**ISSUE:** Certificate of Appropriateness for new construction

**LOCATION:** Parker-Gray District  
1413 and 1415 Princess Street

**STAFF RECOMMENDATION**

**Photo 6: Current East Elevation**

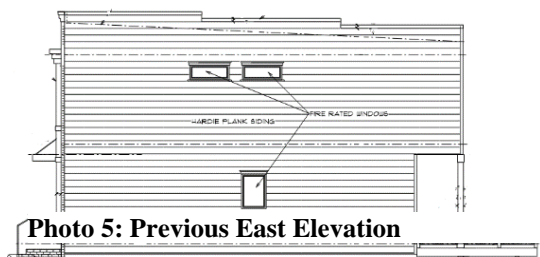
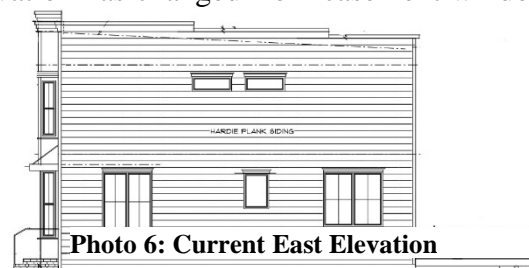
1. The applicant must remove the two pair of windows on the first-story of the east elevation of 1413 Princess St.;
2. The final window specifications for the fire-rated windows at 1413 Princess St. must comply with the Alexandria New and Replacement Window Performance Specifications in the Historic Districts and be submitted with the building permit;

The March 17<sup>th</sup> hearing submission included an east elevation with a reduced number of windows in response to the Board's comments at the November 18, 2020 hearing. The current submission includes two pairs of two-over-two windows on the first story. The applicant should remove the additional windows on the first-story to conform to the previous comments of the Board. Additionally, the windows on the east elevation must be fire-rated windows as required by the building code. At time of permitting, the applicant must submit updated window specifications verifying the use of fire-rated windows on this elevation.

**STREETSCAPE ELEVATION**  
SCALE: 3/8" = 1'-0"

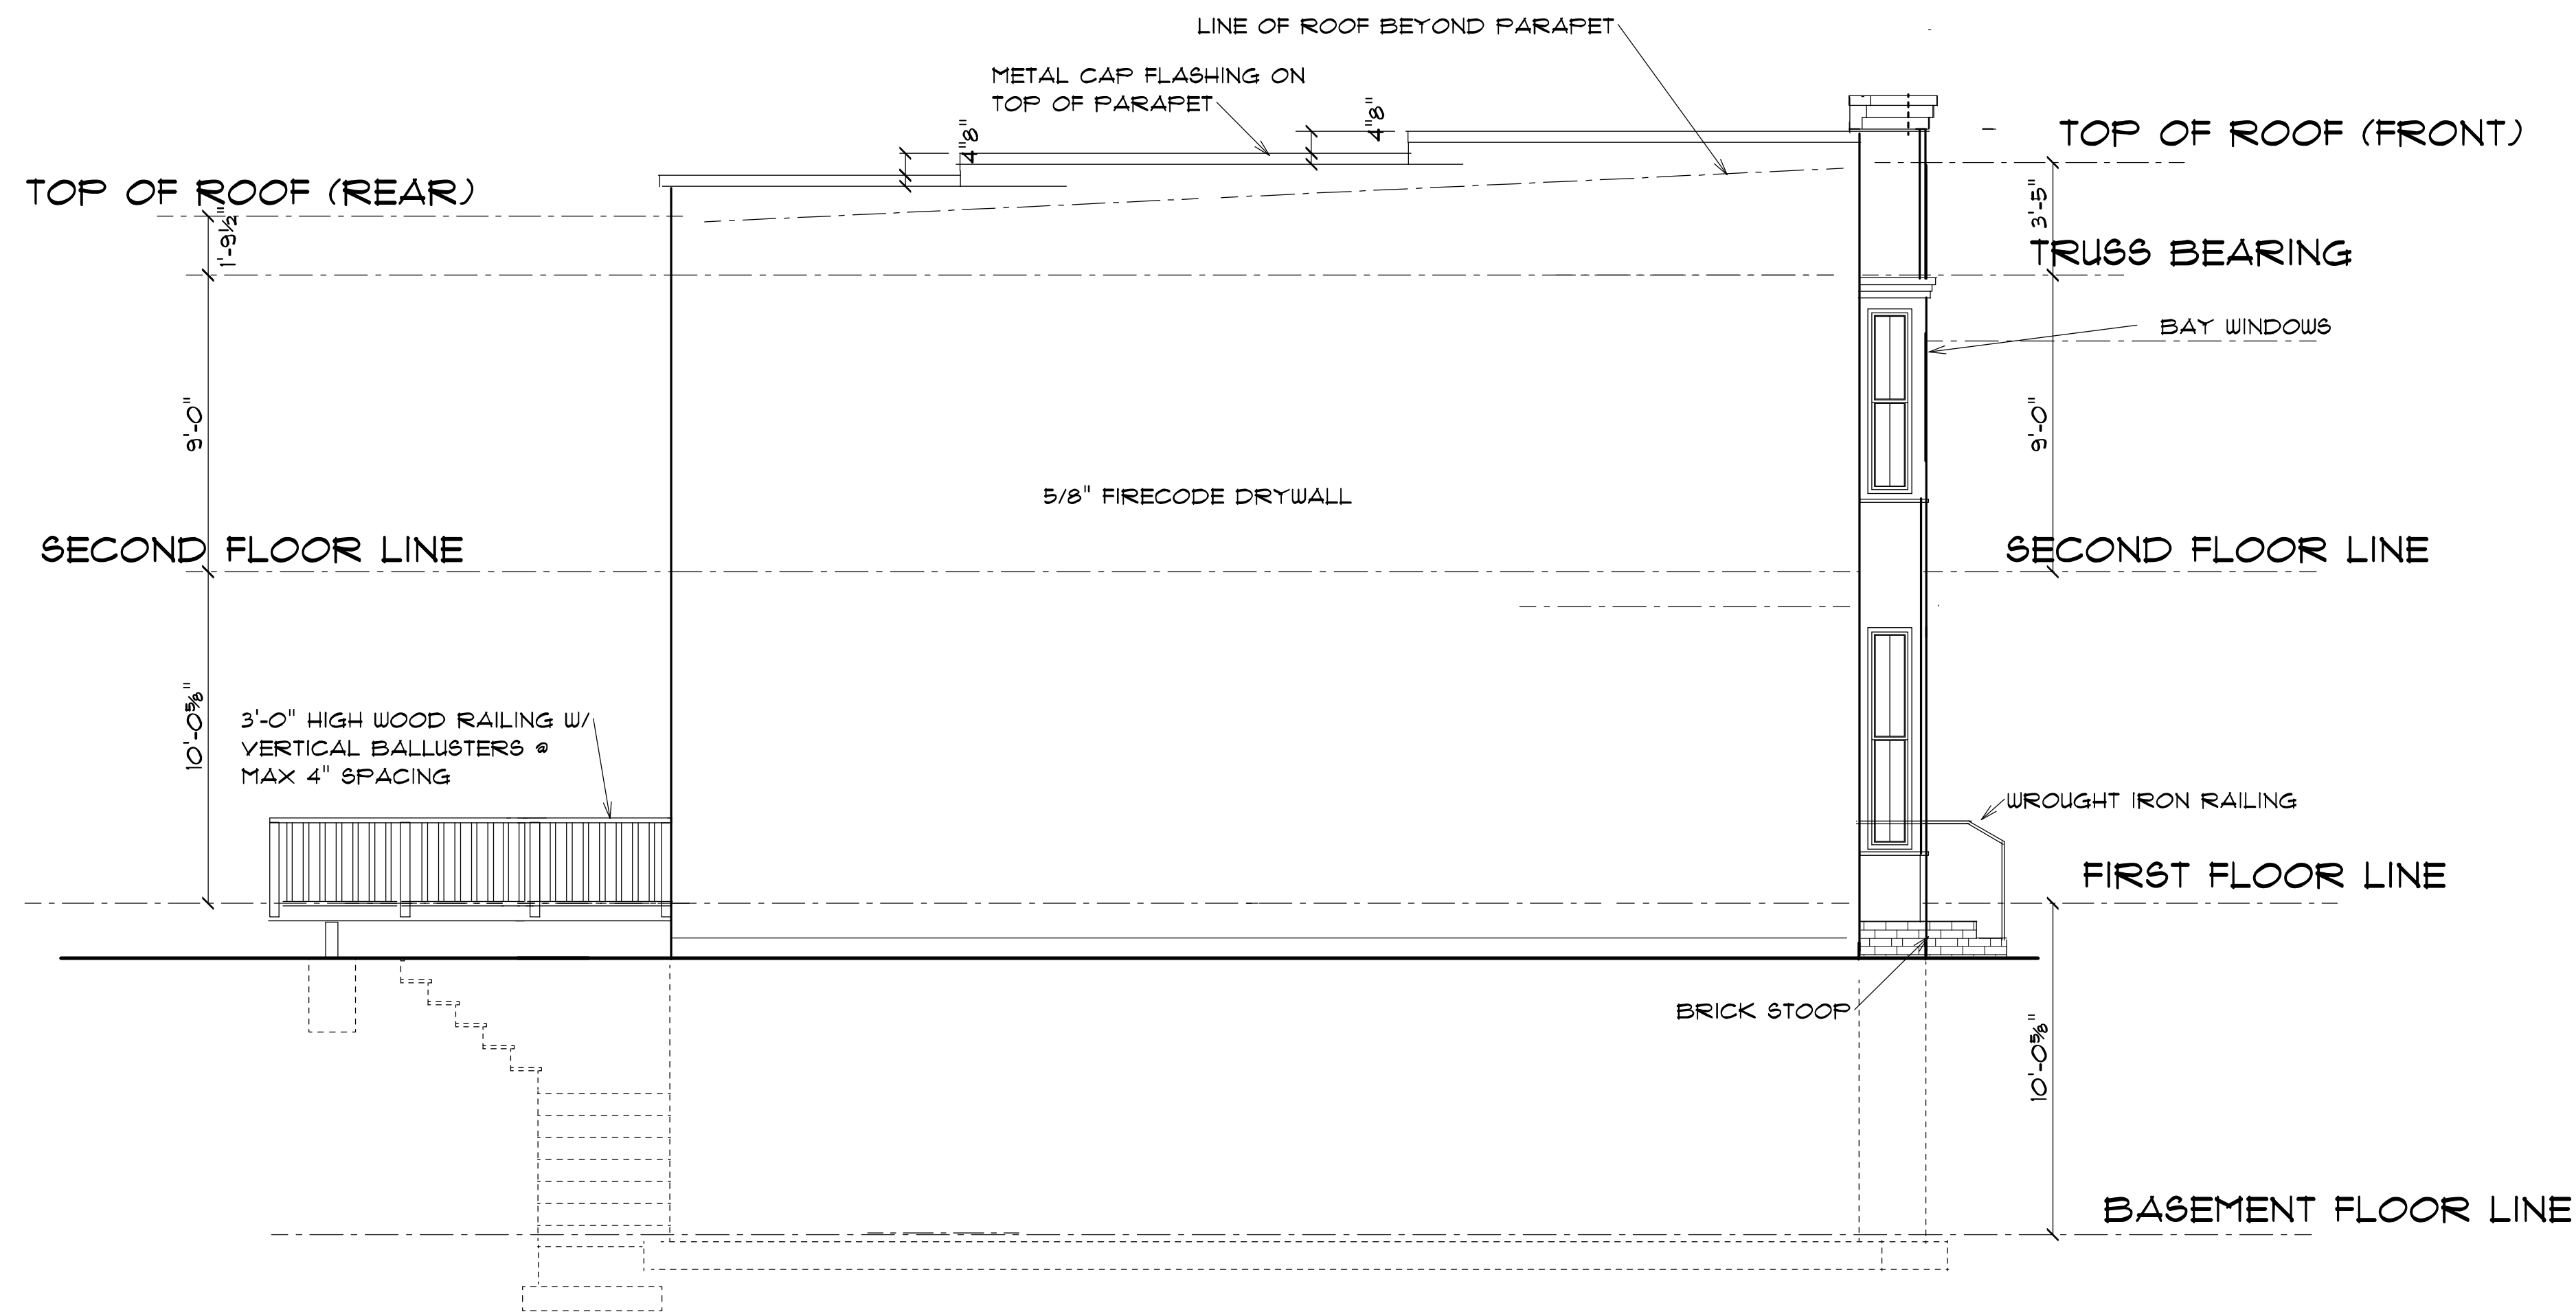
3. Refine the intersection of the bay window and cornices on the south elevation;
4. Refine the trimwork on the proposed bay windows to better reflect the Italianate style;
